Bulletin No:	B391CRM166-0
Release Date:	October 23, 2009
Effective Date:	Immediately
Supersedes:	N/A
Completion Date:	See Text
Page:	1 of 3

# SERVICE BULLETIN

Ride Name: FALLING STAR (Park and Portable Models)

Abstract of Issue:  
Vehicle Axle NDT and Replacement

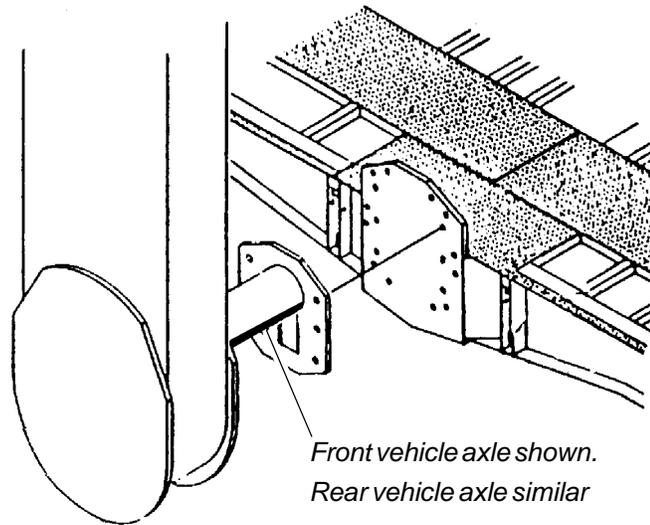
Chance Rides Manufacturing, Inc. has become aware that cracks in the front and rear vehicle axles can occur after many years of operation. Failure of a vehicle axle could result in serious injury to passengers and/or bystanders.

An accurate calculation of the total accumulated axle revolutions is necessary to determine what action must be taken. A sample worksheet is provided on the following page of this bulletin.

**AXLES WITH LESS THAN 3 MILLION REVOLUTIONS MAY CONTINUE OPERATION** until a total of 3 million revolutions is reached. Revolution calculations must be maintained and updated **annually**. It is recommended that these calculations be readily accessible for reference at all times.

**AXLES WITH OVER 3 MILLION REVOLUTIONS MUST BE TAKEN OUT OF SERVICE IMMEDIATELY.** Before the ride can be returned to service, both axles must be removed from the ride for either NDT inspection or replacement with new parts, at the owner's discretion.

- If NDT is performed and no indications are found, the axles can be placed back into service for a period of no more than one year. The NDT inspection of both axles must be performed **annually**.
- If NDT is performed and indications are found, the axles must be replaced with new parts. **DO NOT ATTEMPT TO WELD OR OTHERWISE REPAIR THE VEHICLE AXLES.**
- If, for any reason, the axles are replaced with new parts, the ride can be operated for up to 3 million additional axle revolutions. No annual NDT is required during this period.
